Our Ref: NXG-JBA-XX-XX-L-C-0001-S3-P03-LLFA Response Letter

Response to LLFA Consultation Response regarding Land South of Saceverell Way, Groby, Leicestershire

We write on behalf of Bloor Homes in response to the Lead Local Flood Authority's consultation response dated 24th February 2026 and to provide the additional drainage and flood risk information requested.

The OS plan indicates a flood relief basin to the west of the site.

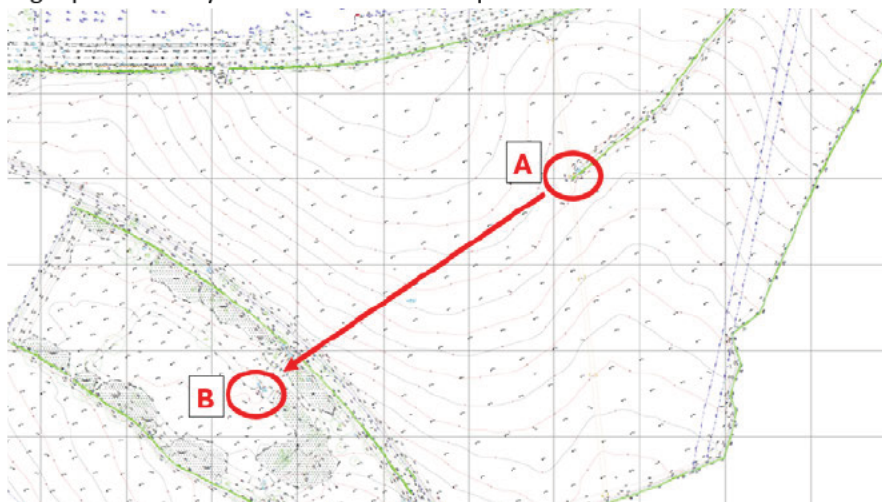
A geophysical survey was carried out which proved that the watercourse connects to the flood relief basin.

- Can you please explain or provide details of this flood relief basin and how the surrounding watercourses interact with it.
- Can we divert the watercourse running centrally towards the flood relief basin and connect to the southern watercourse.
- Who is responsible for these watercourses.
- What is the required easements for these watercourses.
- Would we need to open up the culverted watercourse and keep the same alignment.

The basin is not an asset Leicestershire County Council has produced, as such there is no design data held. From review, it seems likely that this serves the estate at southern Groby to the north of your site before it discharges into the unnamed ordinary watercourse to the southwest. Where there is insufficient information regarding any aspect of risk, the responsibility to investigate falls to the applicant.

Leicestershire County Council acting as Lead Local Flood Authority (LLFA) would be adverse to the proposal of the watercourse transecting the site being wholly diverted, especially if the function of the attenuation basin cannot be identified. It would be preferential that the watercourse be kept in situ and the development proposals designed around the existing land drainage. The LLFA's culverting policy, located in the County Council Flood Risk Management Strategy, welcomes proposals to 'daylight' existing culverted watercourses. Since the LLFA acts as the deciding body on alterations to existing ordinary watercourse under Section 23 of the Land Drainage Act 1991 it would be the ultimate assessor of any proposals here. As such, continued engagement would be welcomed regarding this matter.
